SPARTAN  MOTORS
CHASSIS, INC.

CSB00-0902B

CAMPAIGN SERVICE BULLETIN

Fire Truck Steering Enhancement

FIG. 3-1

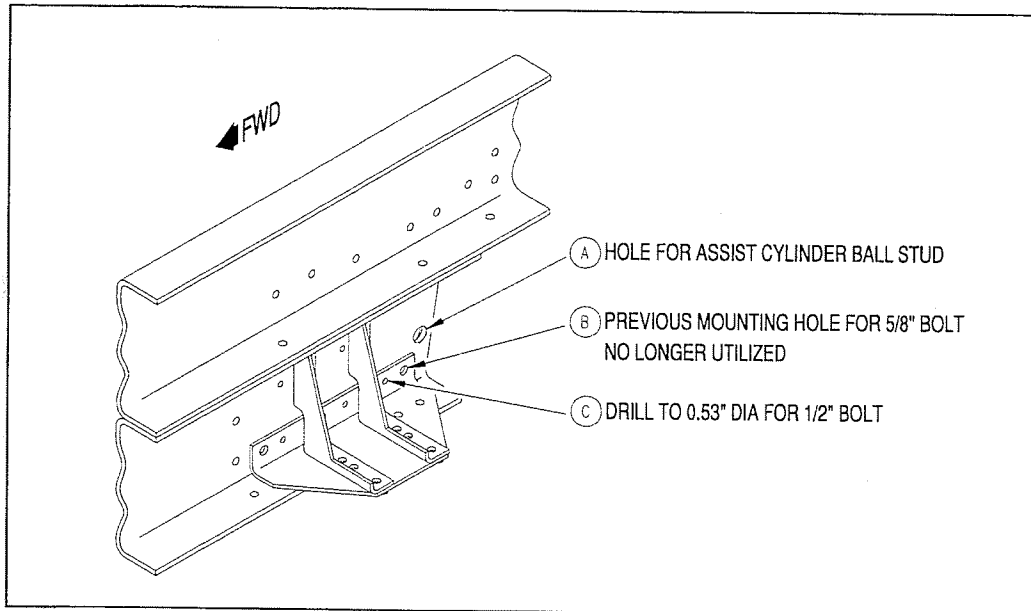
4. Remove and properly dispose of the existing extension plate; retain bolts/nuts for reinstallation.
5. Refer to FIG. 3-1. Locate the assist cylinder attachment hole (item 'A') for the ball stud at the rail. Enlarge the hole to 1.25". An alternative to drilling is to position the new extension plate to the rail and use a pencil type grinder to enlarge the frame rail hole as required.

NOTE: DO NOT allow the hole to become oversize when drilling.

DO NOT attempt to *drill/modify* the frame rail hole with the extension plate in place, as this could distort the tapered hole in the plate.

6. Install the new extension plate with the existing attachment hardware; torque the 1/2" nuts to 105 LBS. FT. The 5/8" bolt attachment is no longer utilized; item 'B', FIG. 3-1.
7. Refer to FIG. 3-1. From the inside of the rail, identify the crossmember attachment hole, which is covered by the new extension plate.

Locate the hole (item 'C') on the crossmember just forward of the covered hole. Drill this hole to 0.53" and install (from outside the rail) the 1/2" bolt/nut; torque to 105 LBS. FT.

FIG. 4-1

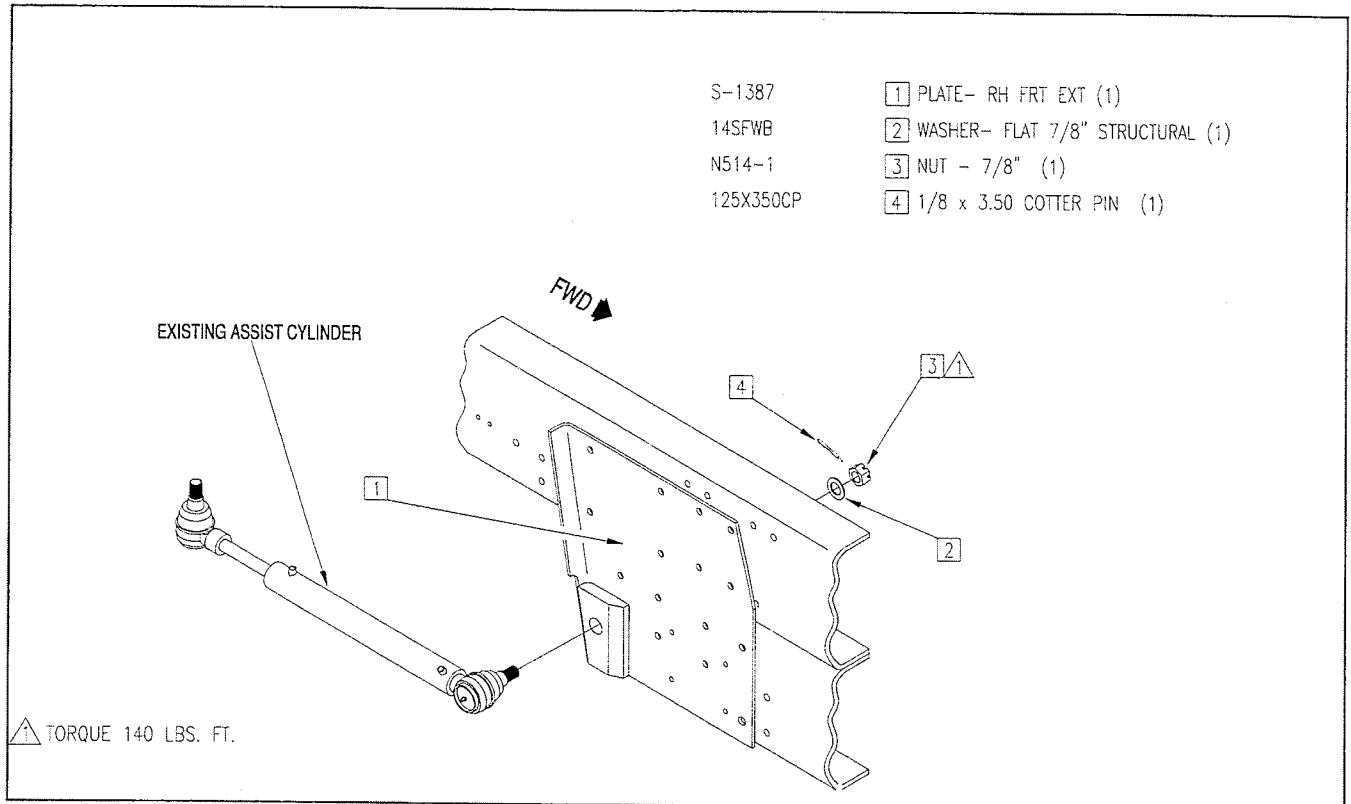
8. Refer to FIG. 4-1. Reinstall the assist cylinder.
 - 8a. Install ball stud of assist cylinder into the attachment hole using the new 7/8" hardened washer and nut as shown.

NOTE: To ensure the taper on the stud fits properly into the taper in the plate, with appropriate thread engagement for the nut, the taper on the ball stud end must protrude inside the frame rail section approximately 0.125" in addition to the lead-in on the thread.

If this cannot be achieved, contact Spartan Motors Chassis, Inc. Customer Assistance Center for further instruction.
